Access Compliance Report

Public Rights-of-Way

(Curb Ramps)

Intersection ID: 11867	Main Street: E_17TH_ST	Cross Street: SEIGLE_AV	Location: E
ADA ID: 938A907951F0	Ramp Type: Perp	Initial Pass/Fail: Fail	Overall Compliance: No
Severity Score: 22.5			
Codes/Mitigation Info/Possible Solution		Field Measurements/Component Compliance

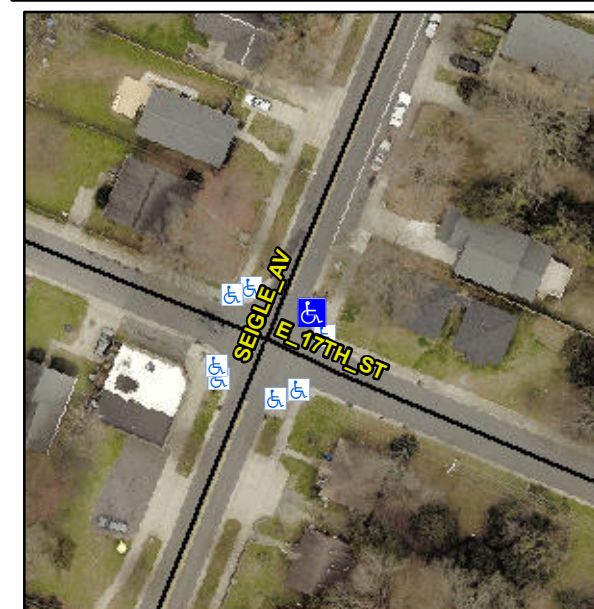
Not Found, R304.5.1, R304.2.2

Compliance	Description	Data	Compliance	Description	Data
N/A	Ramp Length (in)	65.0	No	Ramp Slope (%)	8.9
No	Ramp Width (in)	47.0	Yes	Ramp XSlope (%)	4.3
N/A	Flare Type LT	N/A	N/A	Flare Type RT	N/A
N/A	Flare Slope LT (%)	N/A	N/A	Flare Slope RT (%)	N/A
N/A	Flare Traversable LT?	N/A	N/A	Flare Traversable RT?	N/A
N/A	Landing Length (in)	N/A	N/A	DWS Provided?	N/A
N/A	Landing Width (in)	N/A	N/A	DWS Contrast?	N/A
N/A	Landing Slope (%)	N/A	N/A	DWS Length (in)	N/A
N/A	Landing X Slope (%)	N/A	N/A	DWS Full Width?	N/A
N/A	Landing Curb? (Y/N)	N/A	N/A	DWS Offset (in)	N/A
N/A	Shared Landing?	N/A			
N/A	Gutter Ponding?	N/A	N/A	Gutter Slope (%)	N/A
N/A	Gutter Lip Ht (in)	N/A	N/A	Gutter X Slope (%)	N/A
N/A	Painted X Walk1?	No	N/A	Painted X Walk2?	N/A
	X Walk 1 Direction	To NW		X Walk 2 Direction	N/A
N/A	X Walk 1 Width (in)	N/A	N/A	X Walk 2 Width (in)	N/A
	X Walk 1 Slope (%)	1.2		X Walk 2 Slope (%)	N/A
	X Walk 1 X Slope (%)	7.3		X Walk 2 X Slope (%)	N/A

Remove & Replace Entire Ramp.
